## BOARD OF SUPERVISORS AGENDA ITEM REPORT

**Title:** Regional Flood Control District Technical Policies

**SUBJECT: Regional Flood Control District Technical Policies Revisions**

## 2021 New and Revised RFCD Technical Policy Public Comments and District Response

## FLOODPLAIN MANAGEMENT PRACTICES FOR FENCES / WALLS IN REGULATORY FLOODPLAINS

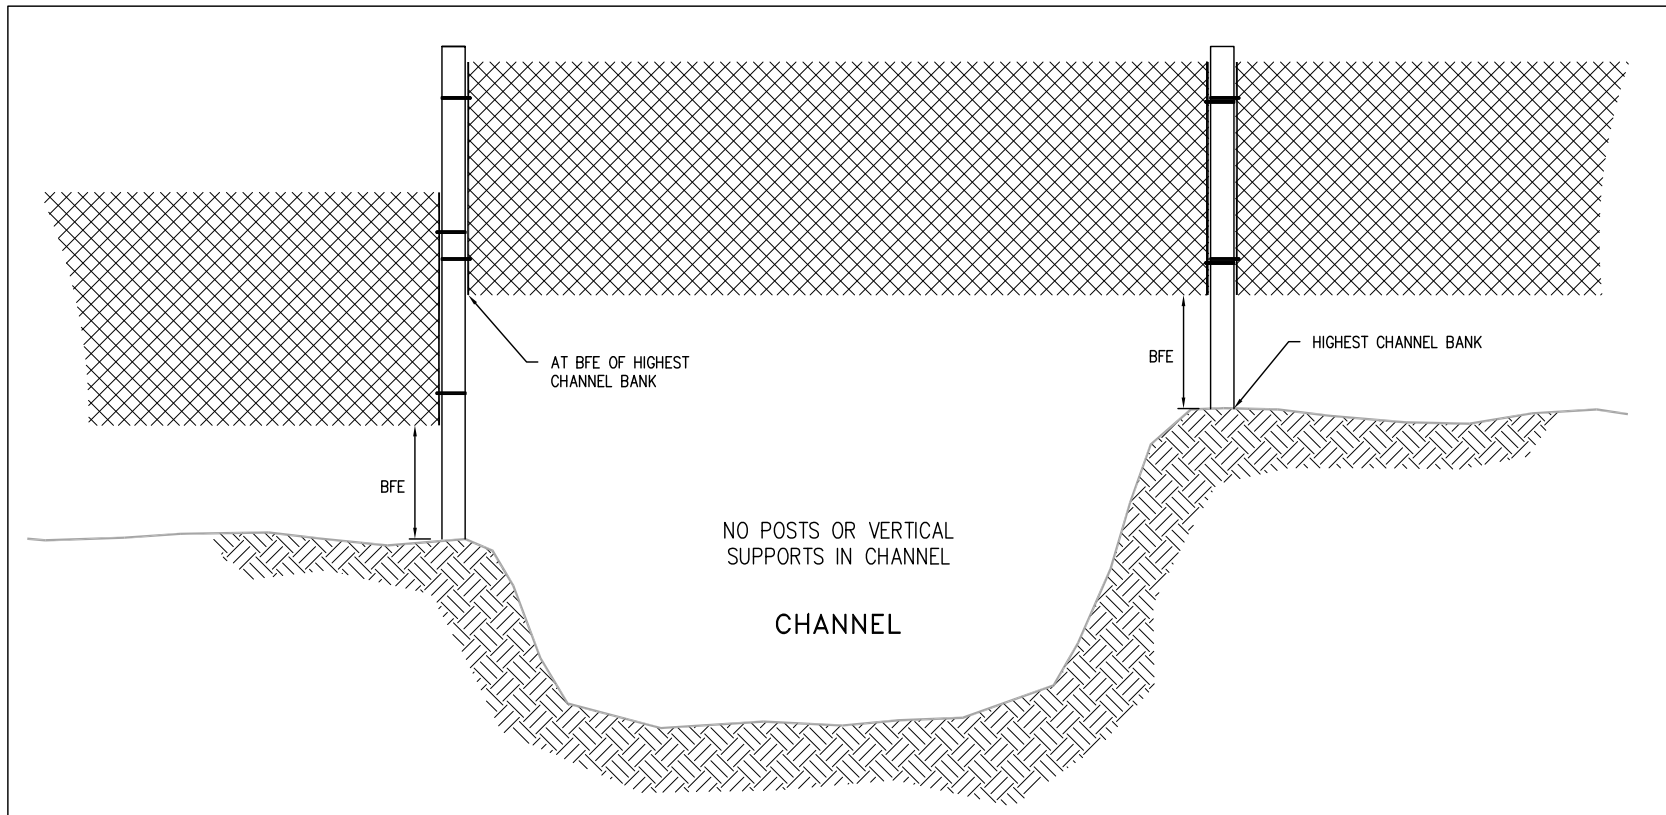
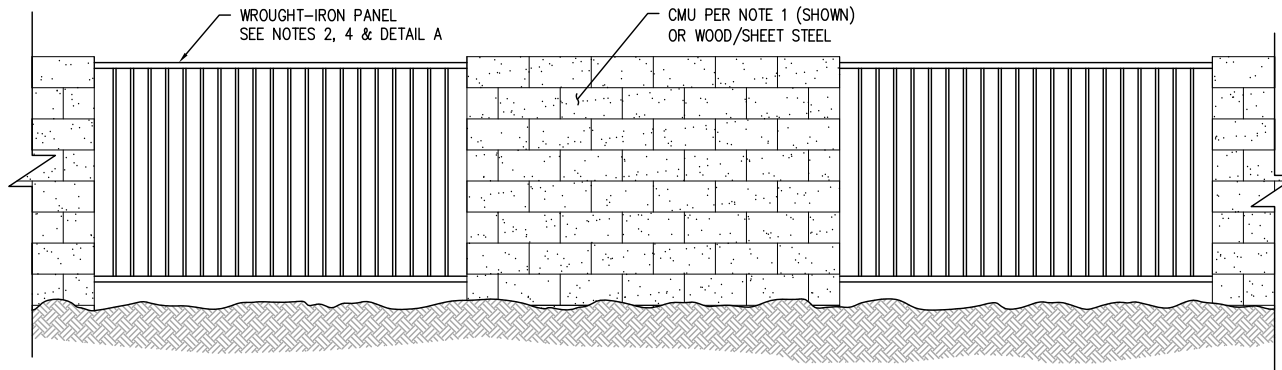
1. Walls and solid fences are not allowed in a floodway
2. Open, pipe rail, wrought iron and woven wire fence are allowed over the channel of a minor regulatory watercourse when constructed as detailed in B.6 and Figure 005-1.

**FIGURE 005-2**

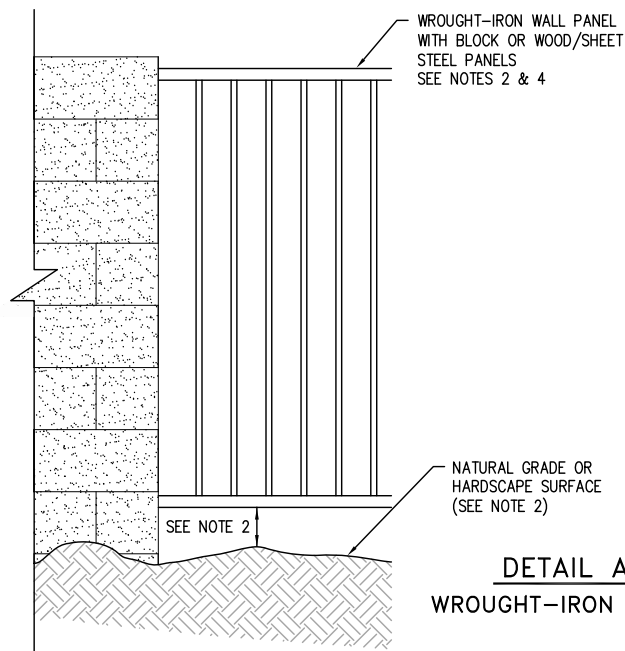
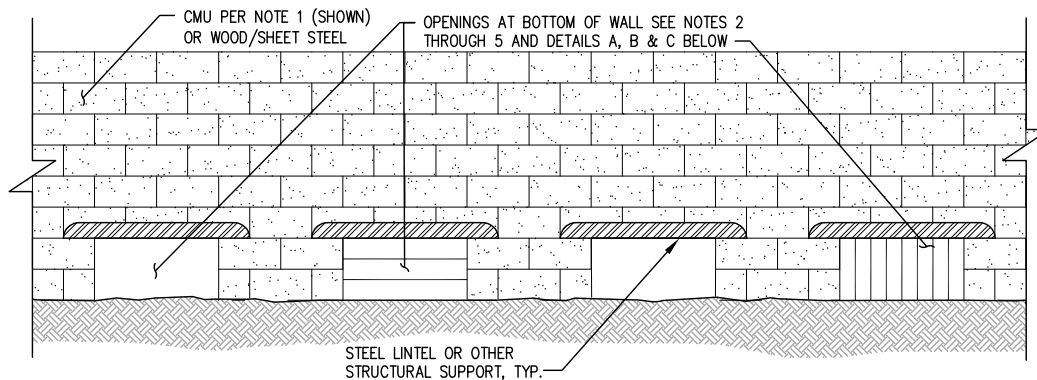
- a. Alternating Ppanels of Ssolid fFence/wall and flood openings provided by panels of Wwrought Iron Ffence Panels, subject to the following minimum standards (see also Figure 005-2):

- iv. and fThe solid portions of the wrought iron fence located below flood level, BFE shall occupy 20% or less of the flow area for an assumed 2 foot flow depth. (See Exhibit D, Sheet 1), or

## FIGURE 005-3 FLOOD OPENINGS LOCATED IN WALL/FENCES IN FLOODPLAINS

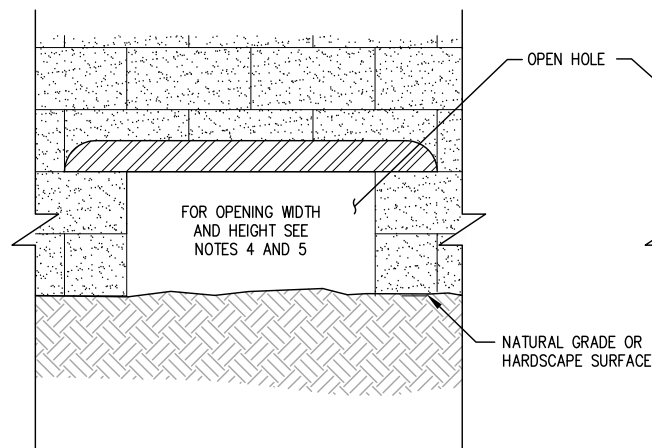
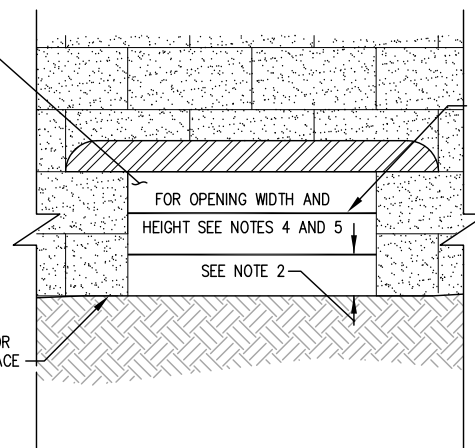
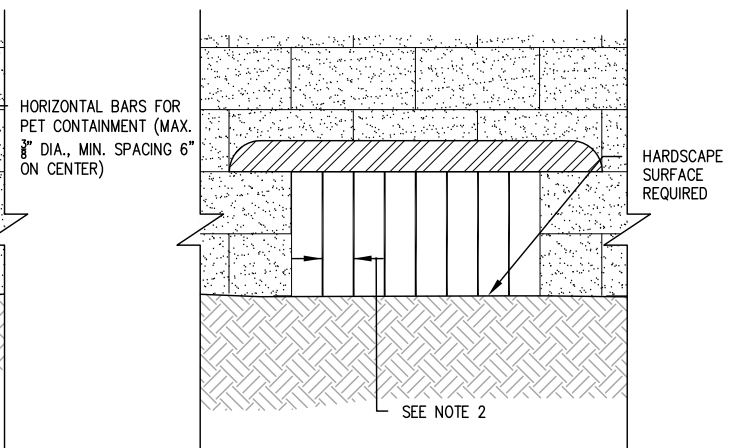
- b. FA solid fence/wall with flood openings provided by Bottom Holes, subject to the following minimum standards (see also Figure 005-3):
- i. The bottom of all openings shall be at natural grade.

- ii. ~~T~~The height of the bottom holes top of all openings shall be at least equal to the 1 percent annual chance flood depth or above the BFE. – If pet containment within the fence/wall is desired, bottom holes/flood openings may be fitted with horizontal bars (3/8 inch max dia-meter) spaced no closer than 6 inches vertically (to be replaced with vertically oriented bars with 4 inches vertical of horizontal spacing if fence/wall provides is a pool enclosure). – (See Exhibit D Figure 005-3 Details B or C, Sheet 2)
